A585 Windy Harbour to Skippool Improvement Scheme

7.9 Comments on Relevant Representations

**A585 Windy Harbour to Skippool
Improvement Scheme**
Development Consent Order 20[]

COMMENTS ON RELEVANT REPRESENTATIONS

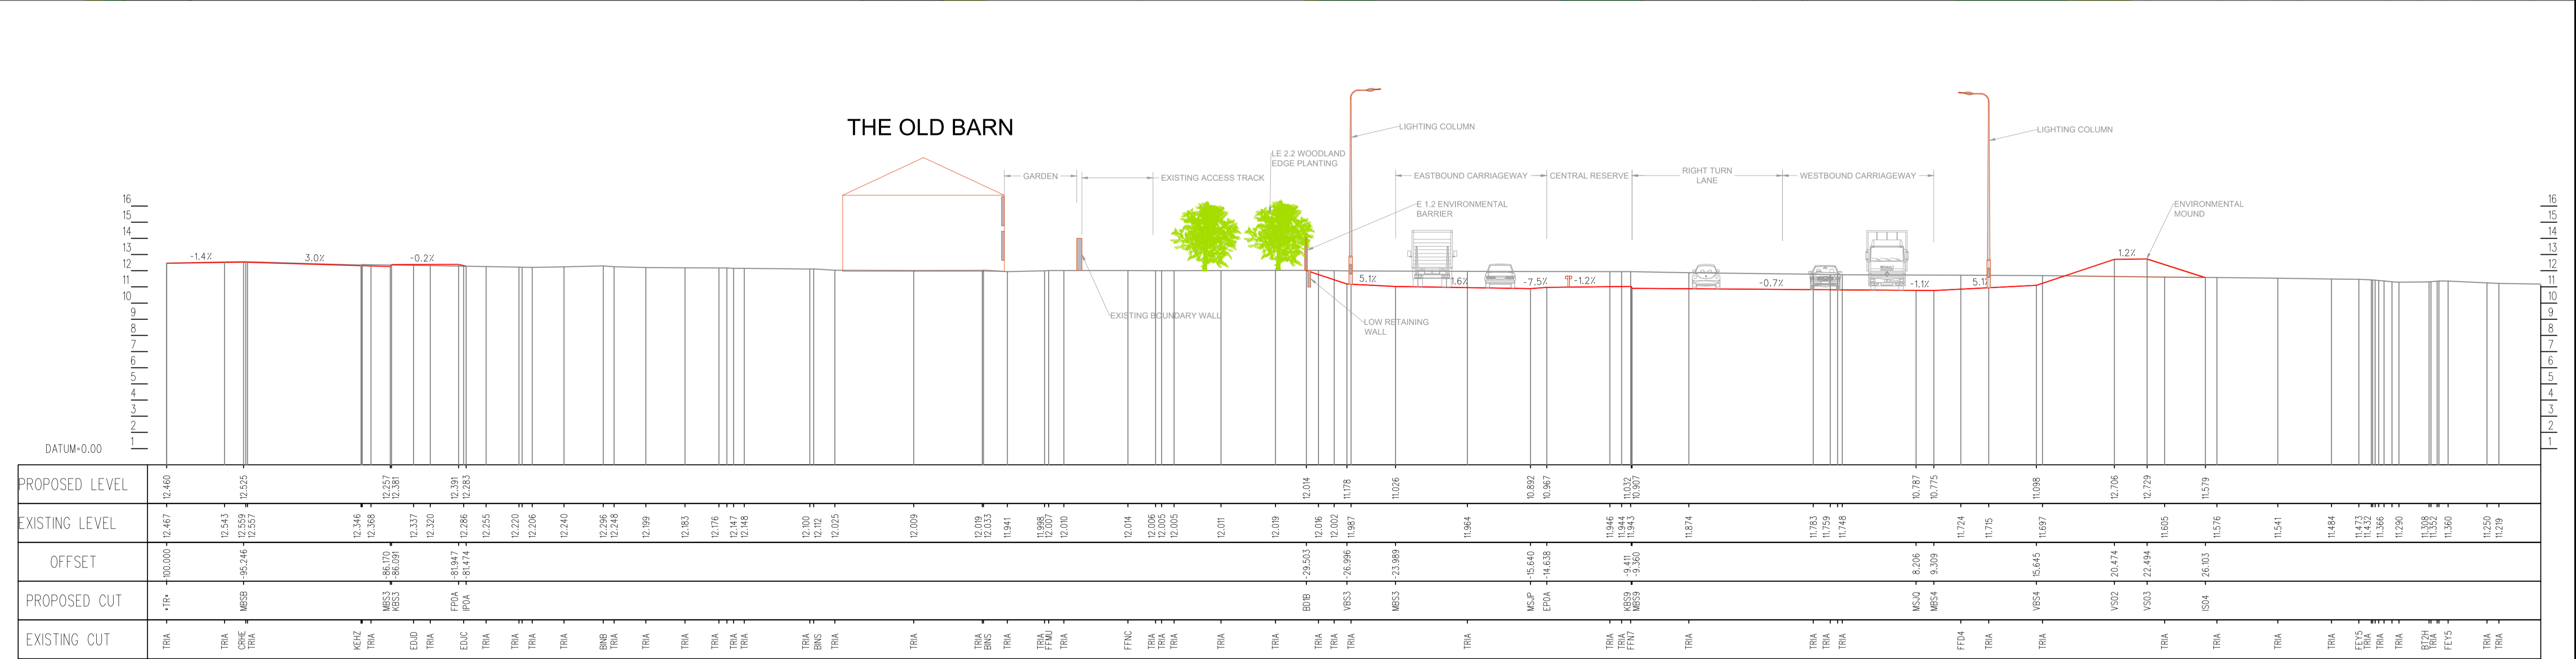
AS-022.6	<p>In failing to Provide a cycle track and footway or a shared path along the side of the new bypass carriageway. -</p> <p>The proposal is to send cyclist and pedestrians up the otherwise closed off old road. This old road will also be used for agricultural access. While at first sight this may appear suitable it fails to meet the IAN 195/16 design criteria.</p> <p>Coherence: For cyclists not familiar with the area tracks that wander away from the signed motor road to their destination are not easy to use and so are generally ignored. They tend to be badly maintained and damaged signs are not replaced resulting in getting lost. In strange areas cyclists will follow signed motor roads.</p> <p>Comfort: While this may initially be OK it will soon deteriorate and will soon be unsuitable for many types of users. Used for agricultural access the surface will very soon be covered in layers of mud from tractor wheels. Hedges and trees will grow out over the path and if the hedges are trimmed the hedge flailings will not be removed and will be a hazard. Rotting leaves will form leaf-mould and slime on the surface. Any cracks or other faults will not be repaired. Several old rural roads that are no longer through routes for motor vehicles but used by cyclists have been neglected so they are now very difficult for both cyclists and pedestrians. The combination of agricultural debris and poor surface maintenance means this will not be suitable for cyclists commuting in clothes suitable for any type of office or retail job. For the same reasons it will not be suitable for many pedestrians.</p> <p>Safety: While this old road will be safe from traffic it does not meet the Safety Criteria. It will be very isolated and for many ladies, both cyclists and pedestrians, it will not feel safe. Also many parents will not want their children to use such an isolated lonely route.</p> <p>TA 91/05 also draws attention to the need for personal security.</p> <p>8.31 Designers need to take account of personal security issues when designing an NMU route. OCRs within or adjacent to the highway verge will bring about a degree of perceived and actual personal safety if a sufficient visual and physical connection with the carriageway can be maintained.</p>	<p>There would be no prohibition for cyclists but there would be encouragement for them to use the cycle route, refer to the General Arrangement plans (document reference TR010035/APP/2.5). Local Transport Note LTN 2/08 indicates it is likely that "fast commuter" or "sports cyclists" would use the bypass as they are "confident in most onroad situations and will use a route with significant traffic volumes if it is more direct than a quieter route".</p> <p>The design considerations for cyclists was that no specific provision would be made along the bypass due to: (1) High traffic speeds on the bypass, (2) Non-provision of lighting along most of the route (3) Alternative routes using the sections of roads to be bypassed form a more direct and quieter route between the local communities.</p> <p>The alternative routes proposed use parts of the existing road network to be bypassed and/or de-trunked and are considered to adhere to the five design criteria described in IAN 195/16.</p>
